## HISTORIC AND DESIGN REVIEW COMMISSION

Agenda Item No: 23

**HDRC CASE NO:** 2017-029  
**ADDRESS:** 321 REFUGIO ST  
**LEGAL DESCRIPTION:** NCB 714 BLK 11 LOT S IRR 49.6 FT OF 13  
**ZONING:** RM-4, H  
**CITY COUNCIL DIST.:** 1  
**DISTRICT:** Lavaca Historic District  
**APPLICANT:** Criswell Humphrey/CCH Projects  
**OWNER:** Criswell Humphrey/CCH Projects  
**TYPE OF WORK:** Porch modifications, fencing  
**REQUEST:**

**PLOT (SITE) PLAN**

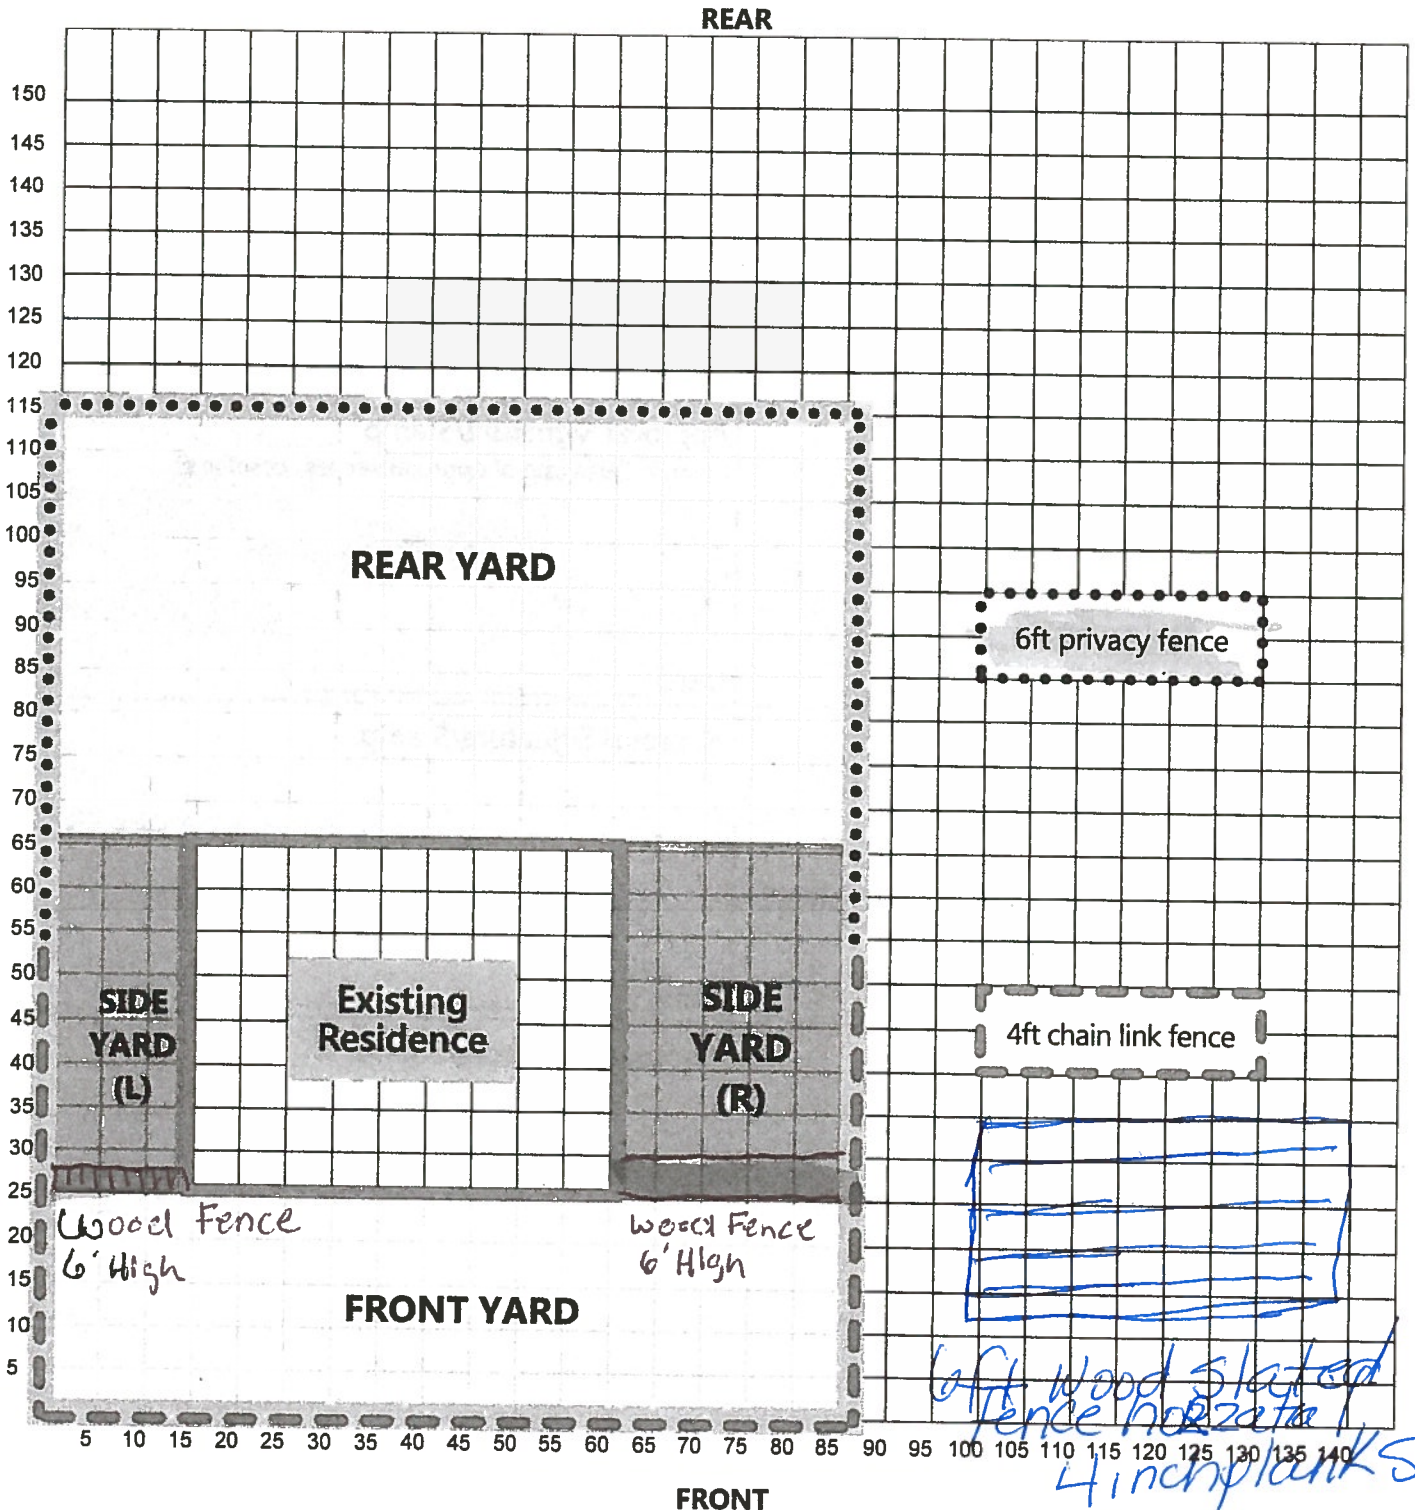
we want to replace this Fence with a wooden Fence  
6' Feet high

We Sealed  
a door that  
was here
